Serial No. 19-077A
NRA/SS R0
Docket No. 50-423
License No. NPF-49

DOMINION ENERGY NUCLEAR CONNECTICUT, INC.
MILLSTONE POWER STATION UNIT 3
REVISED RESPONSES FOR TWO REQUEST FOR ADDITIONAL INFORMATION
QUESTIONS FOR PROPOSED TECHNICAL SPECIFICATION CHANGES FOR
SPENT FUEL POOL STORAGE AND NEW FUEL STORAGE

**REVISED RESPONSES FOR TWO REQUEST FOR ADDITIONAL INFORMATION
QUESTIONS FOR PROPOSED TECHNICAL SPECIFICATION CHANGES FOR
SPENT FUEL STORAGE AND NEW FUEL STORAGE**

**MILLSTONE POWER STATION UNIT 3
DOMINION ENERGY NUCLEAR CONNECTICUT, INC.**

Figure 9.1 – KENO Region 2 6x6 Model

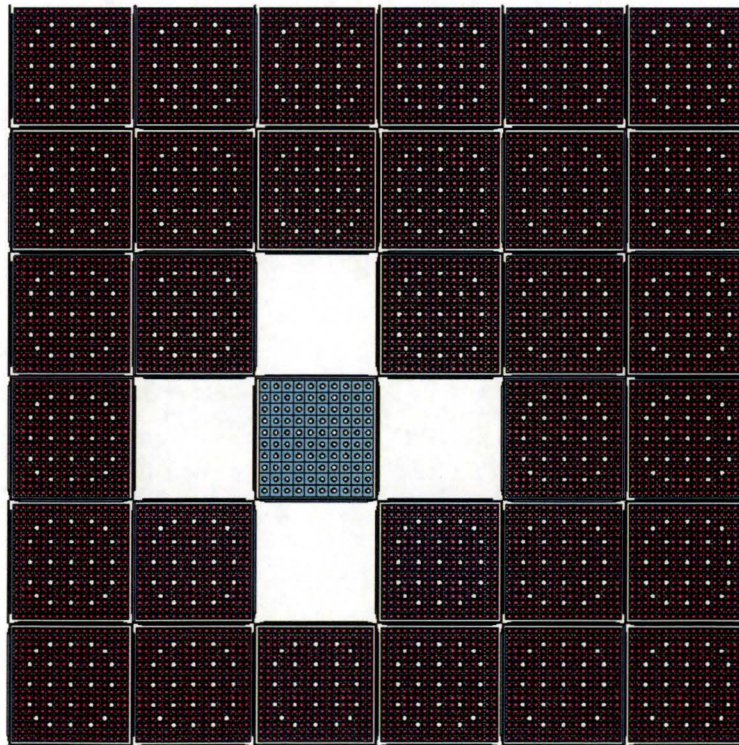
- a. *Region 1 wasn't explicitly modeled. Confirm that the requirement for storage cells that are face adjacent to the fuel assembly being reconstituted will also be applied to Region 1.*
- b. *The analysis did not address the number of fuel rod lattice locations that can be empty during the reconstitution process. Specify the number of fuel rod lattice locations that can be empty during the reconstitution process.*
- c. *The analysis addresses one fuel assembly with two empty fuel rod lattice locations. How would the licensee address other fuel assemblies with empty fuel rod lattice locations?*

With the reconstitution fuel assembly isolated, there is no limit on the number of empty fuel lattice locations. Confirmation is provided in Table 9.1. The Region 2 reconstitution model (LAR Attachment 5 / 6, Table 11.2) is modified by replacing the normal reconstitution fuel assembly near the center of the model with uniform pitch fuel lattices of varying number of fuel rods per side (maintaining the normal fuel assembly envelope) and, for some cases, varying rod pitch with the same reduced number of fuel rods. Varying the number of fuel rods and rod pitch will iteratively search for the optimum fuel to moderator ratio. KENO cases have no soluble boron and are run with moderator temperature set to 32°F. Figure 9.1 shows the configuration of the 100 fuel rod reconstitution model. Region 2 results were confirmed to also be valid for Region 3. As stated in RAI response 9a, Region 1 is bounded by Regions 2 and 3.
